**Written submission from
Frank R. Greening**

**Regulatory Oversight Report for
Canadian Nuclear Power
Generating Sites: 2018**

Commission Meeting

November 6, 2019

Figure 1

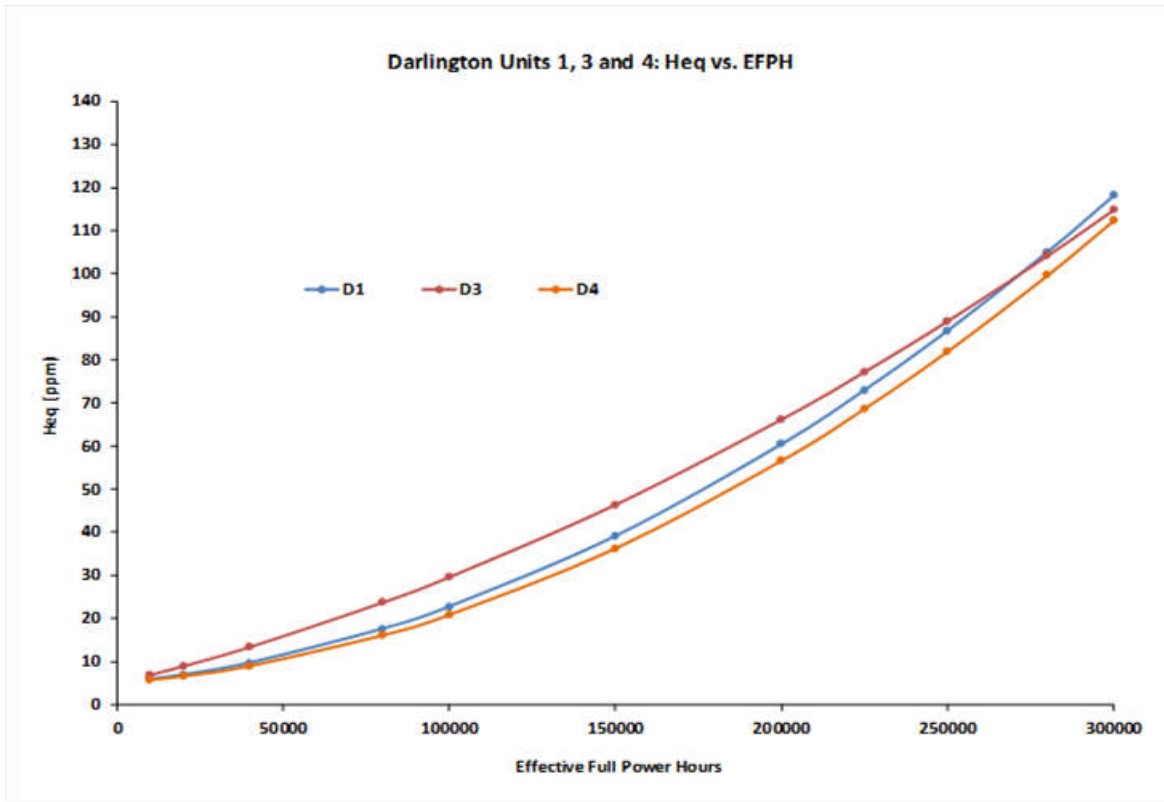
To illustrate the use of this methodology I have carried out detailed calculations for Darlington Units 1, 3 and 4, (Darlington Unit 2 was excluded from the study because it is currently shut down for a full refurbishment). The results of this study are presented in Figures 1 and 2, below.

Figures 1 and 2 show that although H_{eq} remains below 120 ppm for Darlington Units, 1, 3 and 4 out to 300,000 EFPH of reactor operation, $\Delta H_{eq}/10^4$ HH *exceeds* 3 ppm before these Units reach 150,000 EFPHs. Furthermore, at the present time, (September 2019), $\Delta H_{eq}/10^4$ HH now exceeds 4 ppm. Thus, we conclude that these Darlington Units are non-compliant with CSA N285.4 because they do not satisfy all of the acceptance criteria of Clause 12.3.5.2. of this Standard.
